DS-K1T642 Series MinMoe Terminal Release Notes (2022-04-09)

Device Model: DS-K1T642M DS-K1T642E DS-K1T642MF DS-K1T642EF DS-K1T642MW DS-K1T642EW DS-K1T642MFW DS-K1T642EFW Naming Rule: M for M1 card, E for EM card, F for fingerprint, W for Wi-Fi	Firmware Version	ARM: ACS_641_AI3_EN_STD_V3.2.30_build220311 ACS_641_AI3_EN_NEU_V3.2.30_build220311
	SDK	Latest version
	iVMS-4200	Latest baseline

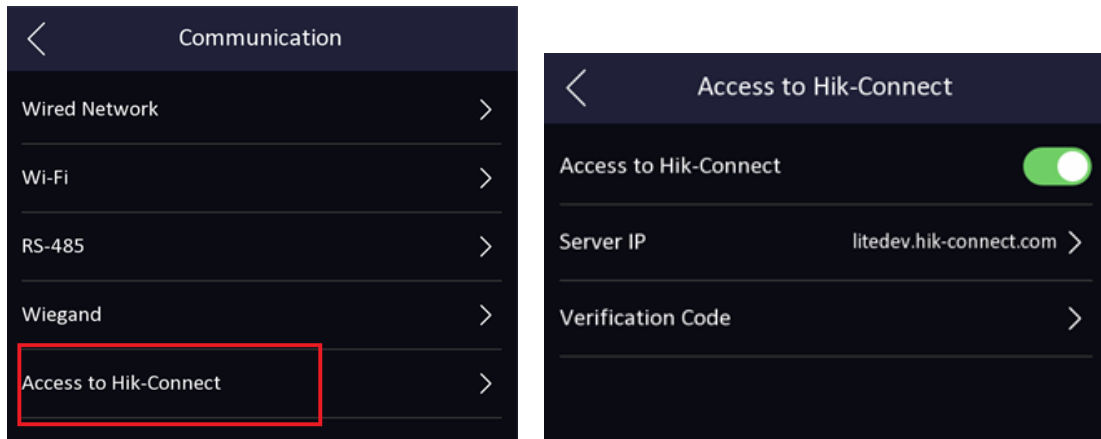
1. Add Hik-Connect menu in device UI Menu → Comm. The function is disabled in default.

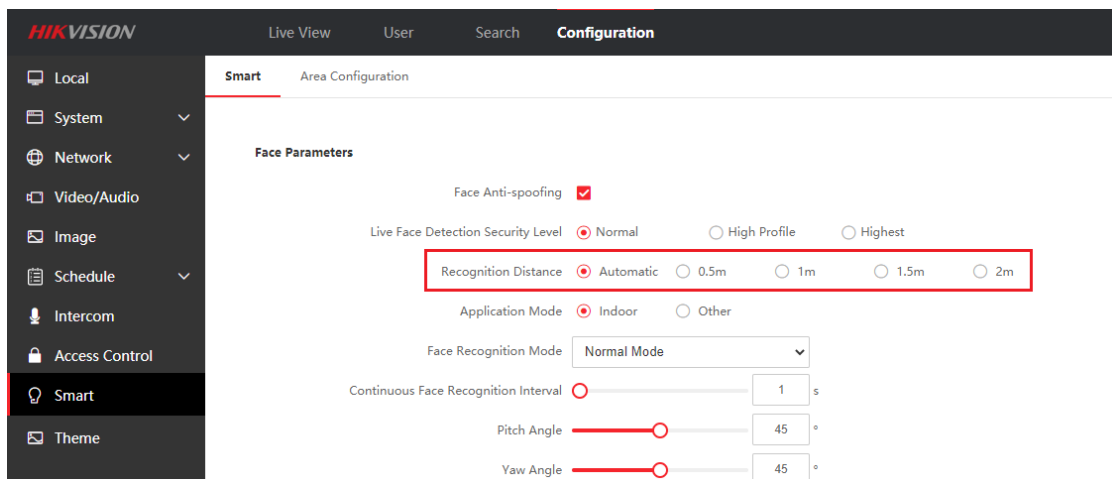
1. Optimize the wake-up distance of the device screen through the face, and the wake-up distance is consistent with the recognition distance

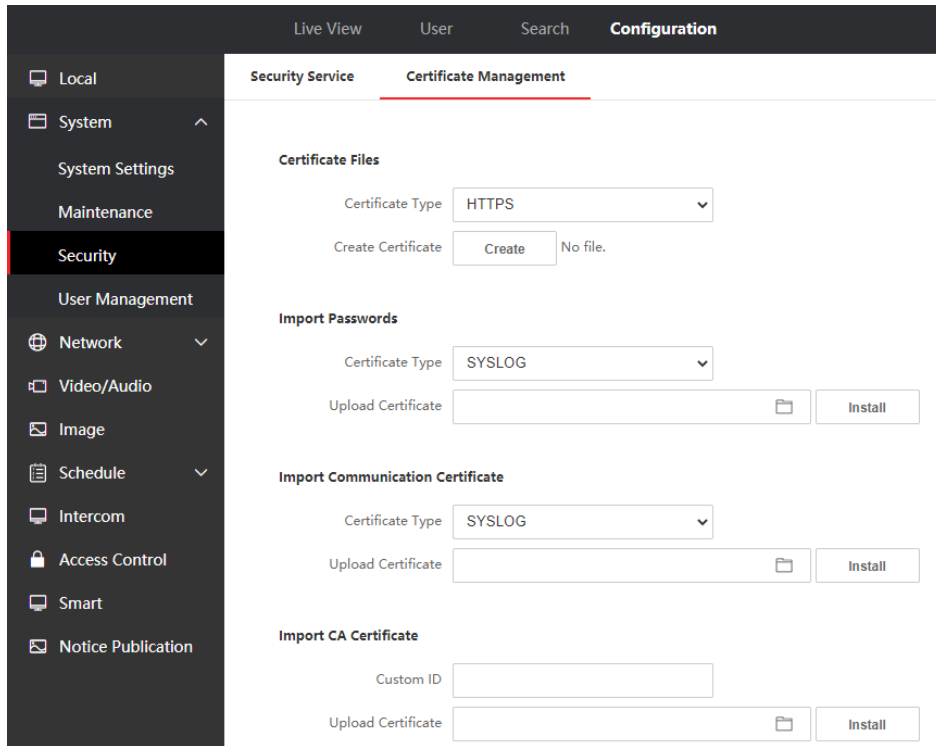
1. Support https feature

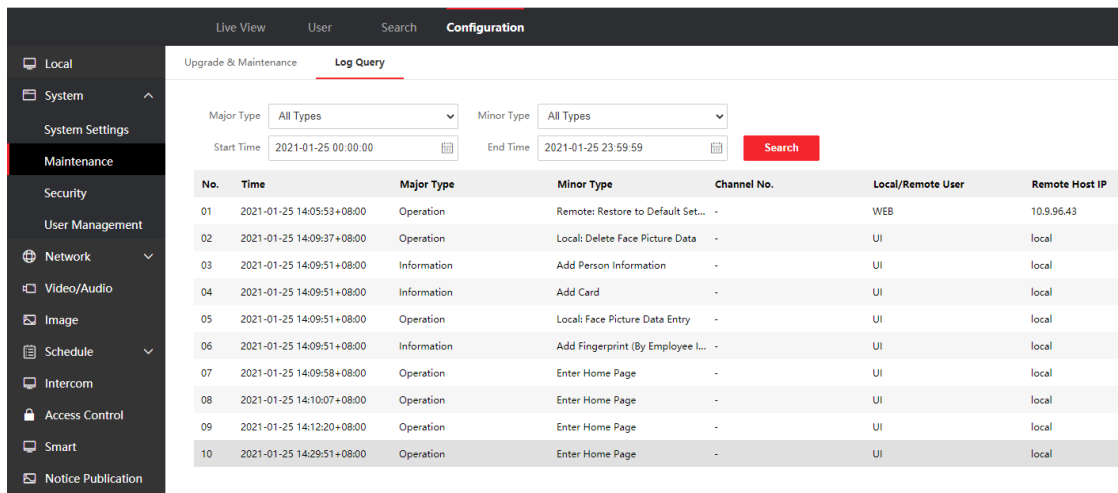
2. Support English, Spanish (South American), Arabic, Thai, Indonesian, Russian, Vietnamese, **Brazilian Portuguese**
3. Add Hik-ProConnect platform docking
4. Add device operation log query function

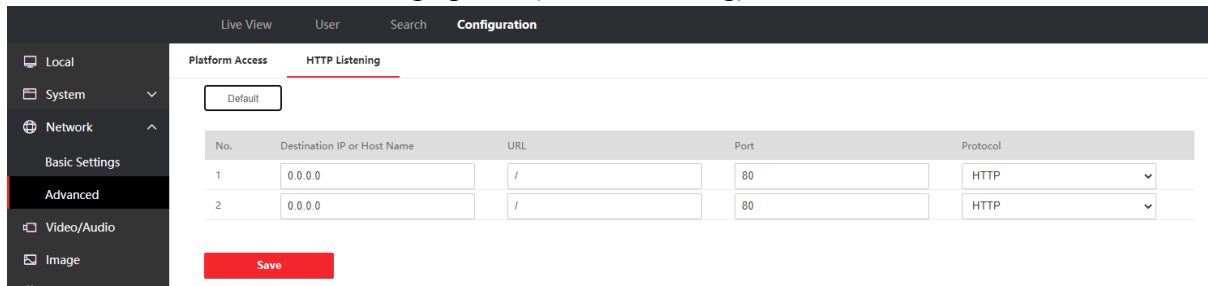
5. Add ISAPI event monitoring upload (HTTP listening) function

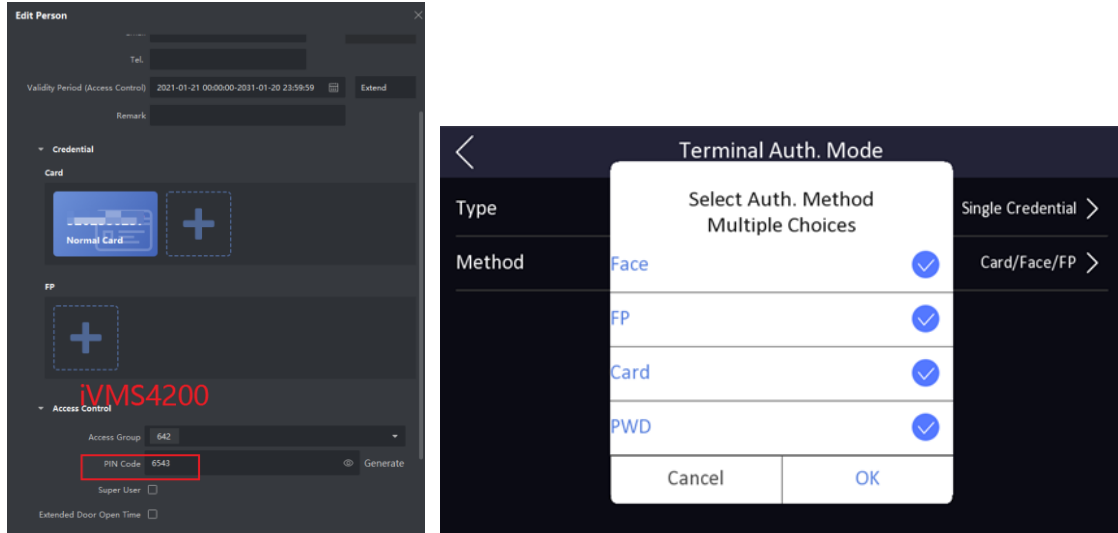
6. Open the door with PIN code (disabled in default).
7. **Note:** PIN code should be configured from software, iVMS4200 already support, HikCentral Pro will support PIN code configuration in V2.1 expected to be released in June

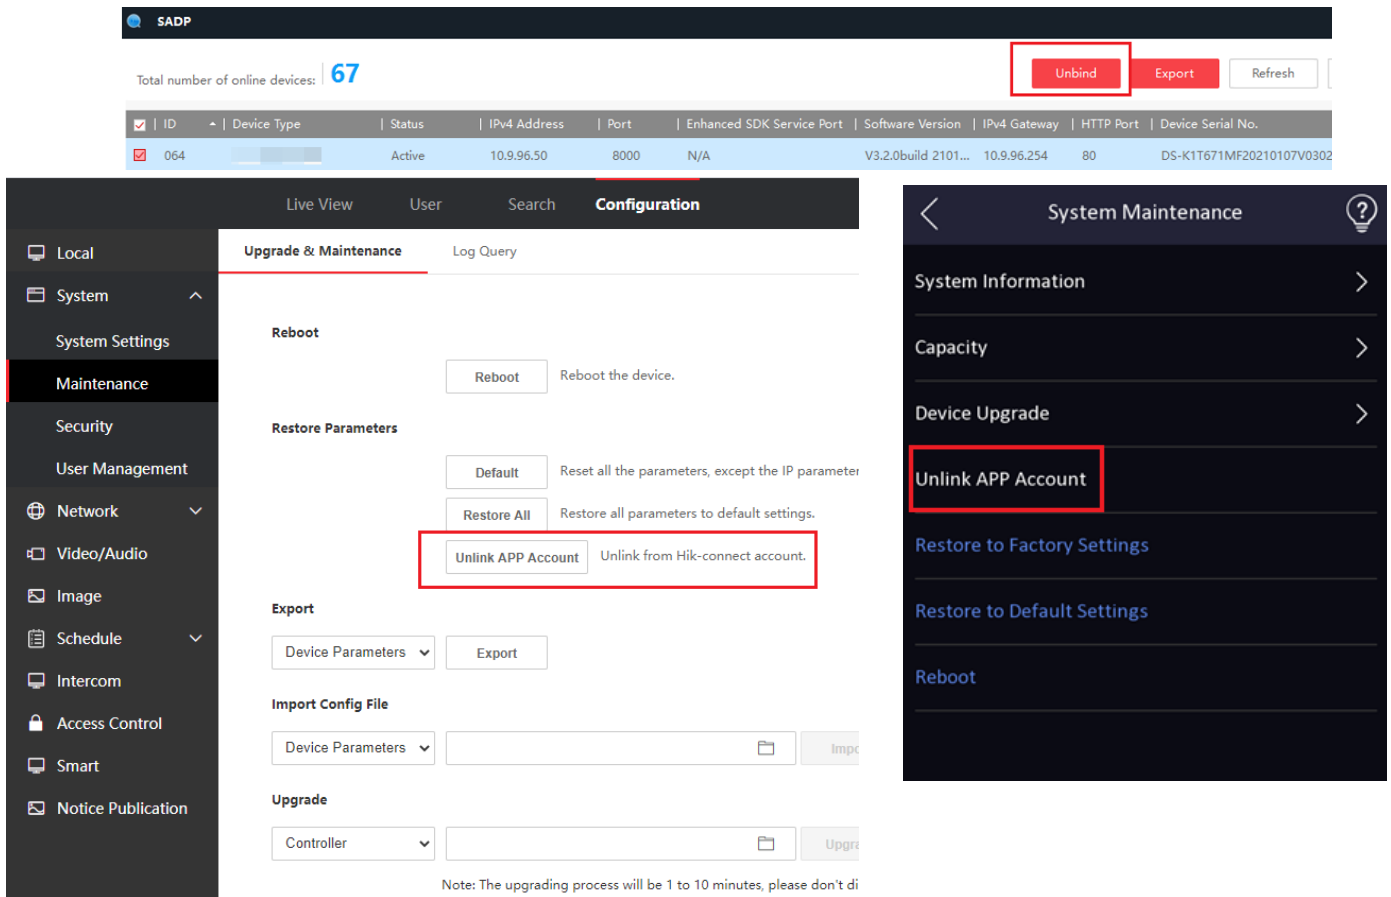
8. Support unbind device with hik-connect account on SADP tool, local UI and web interface

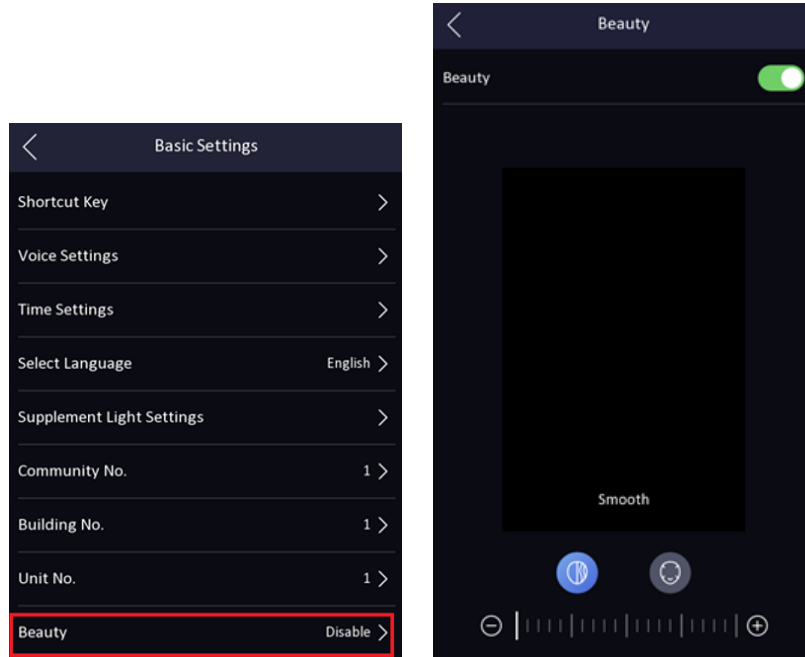
9. Add beauty function to adjust smooth and whiten parameter.

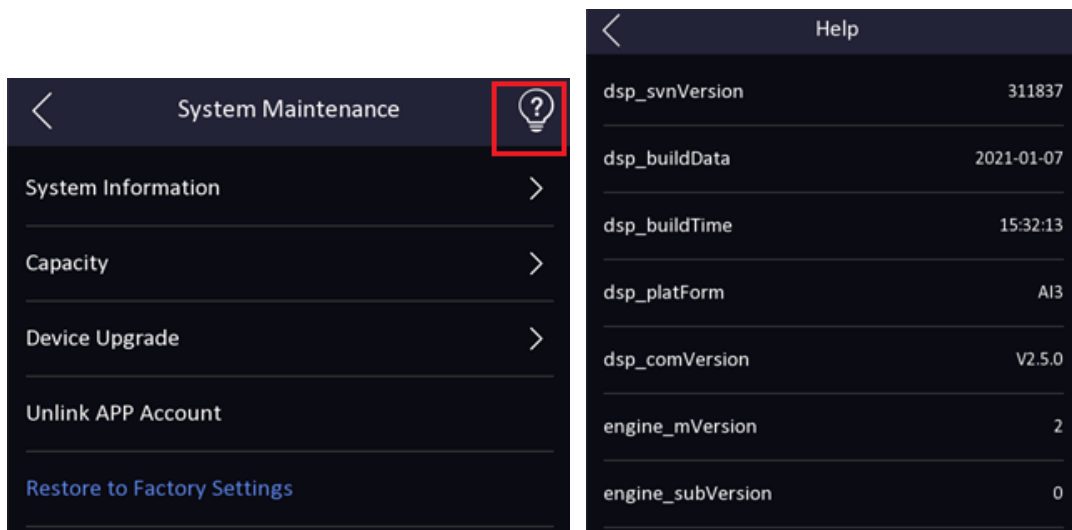
10. Add help interface to check system module version for technical support (long press for 3s).

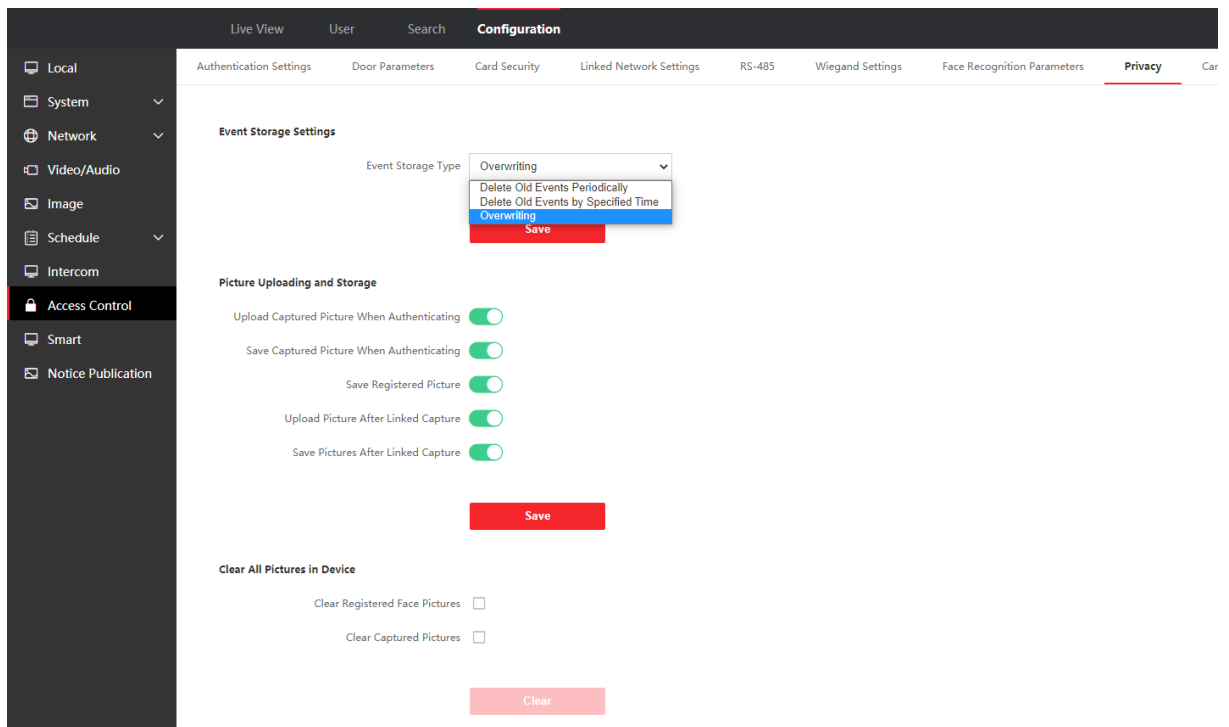
11. Add privacy protection, customer can define the privacy related parameter, such as Event Storage Settings, Picture Uploading and Storage, Clear All Pictures in Device

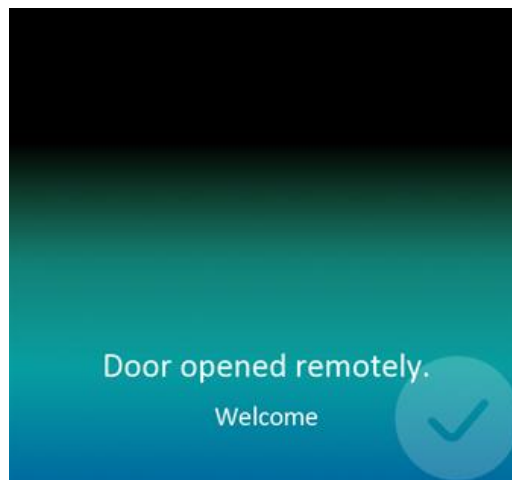
12. Add audio prompt 'The door is open' when open door on iVMS4200, HikCentral Pro, Hik-Connect App, and device UI will show prompt

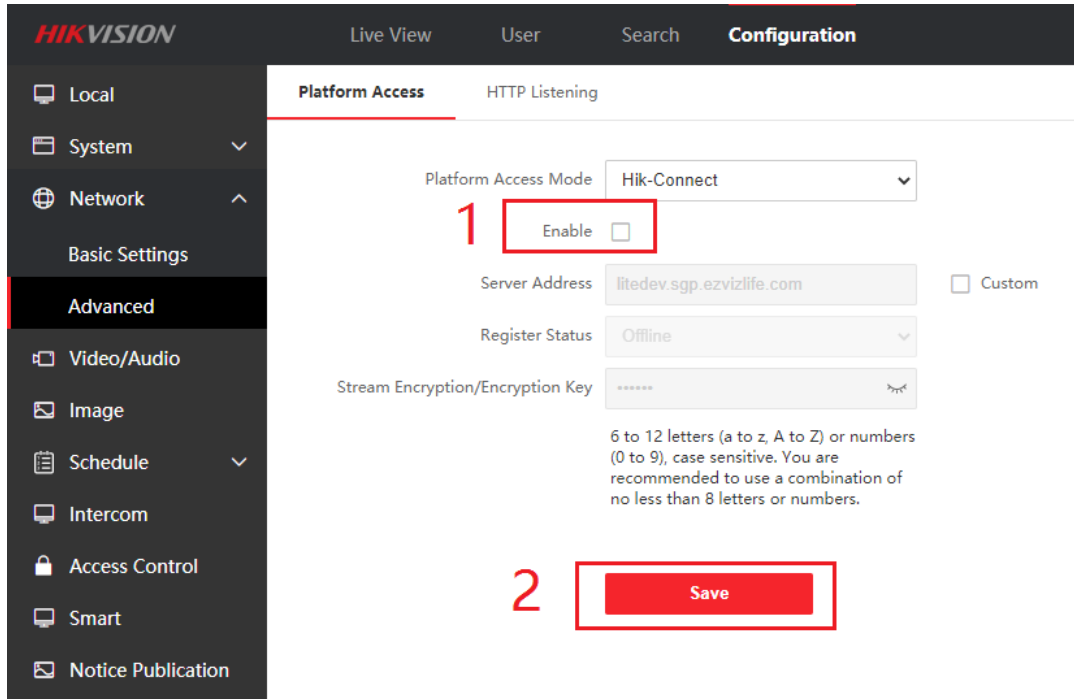
4. Hik-Connect function is turned off in default for privacy protection, if customer want to manage device from App, please turn on manually in the web.

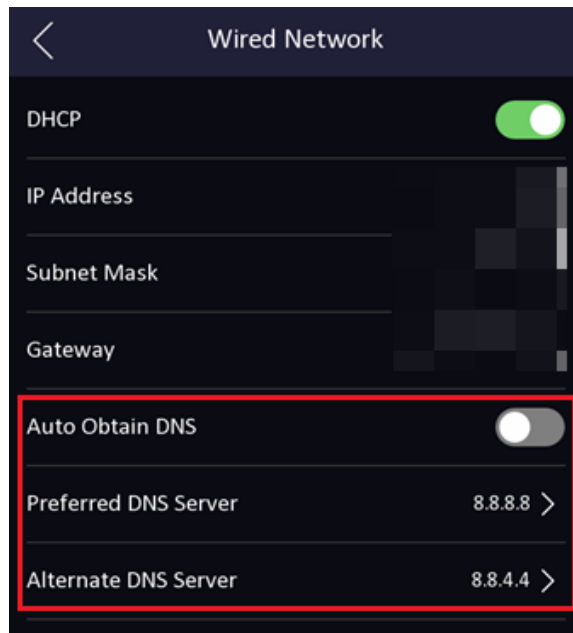
- The face matching algorithm is upgraded. Improve the speed and accuracy of face recognition. Improved the recognition effect of dark masks
- DNS can be configured from device UI in menu → Comm.-->Wired Network

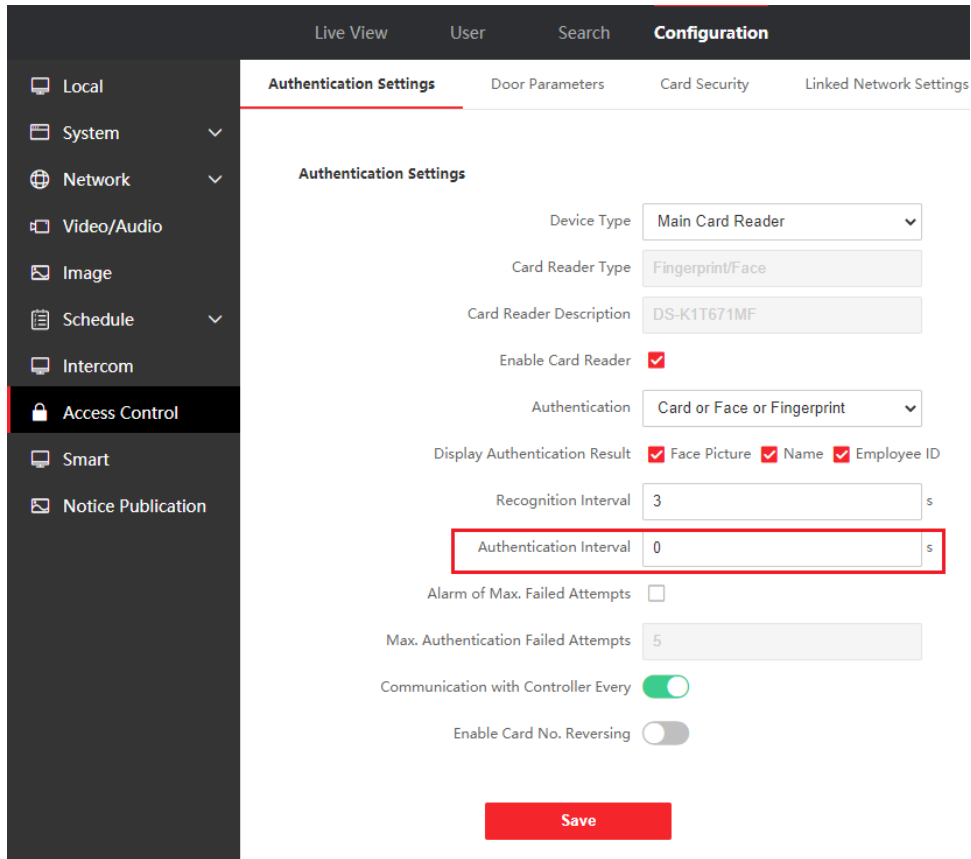
- Optimized the ISUP and Hik-Connect event upload mechanism.
- Add stranger authentication timeout time configuration.

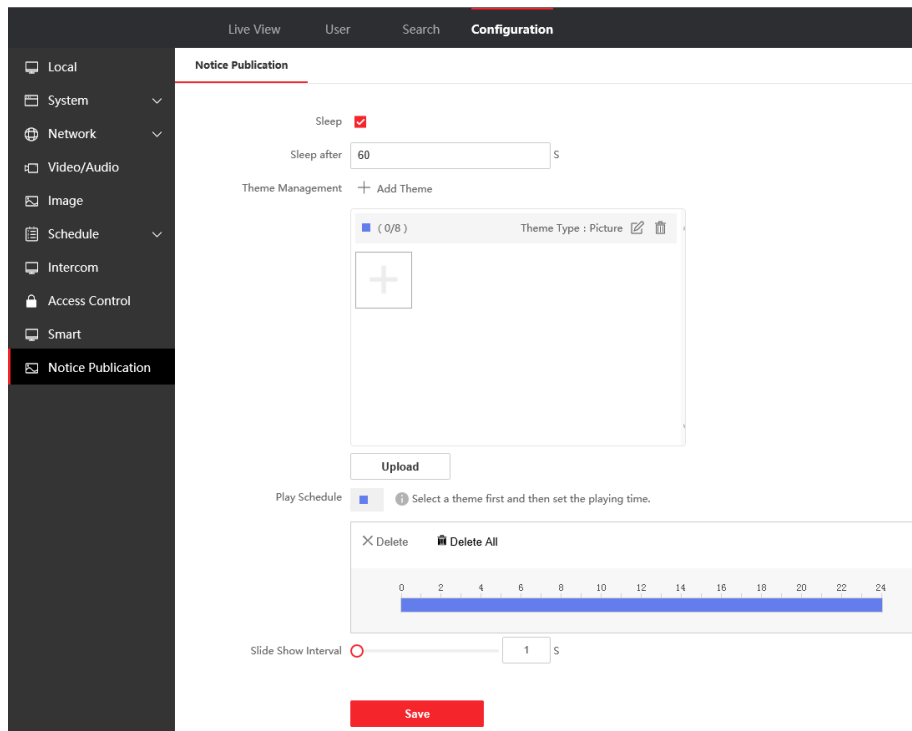
9. Add advertisement/wallpaper play schedule configuration, slide show interval.
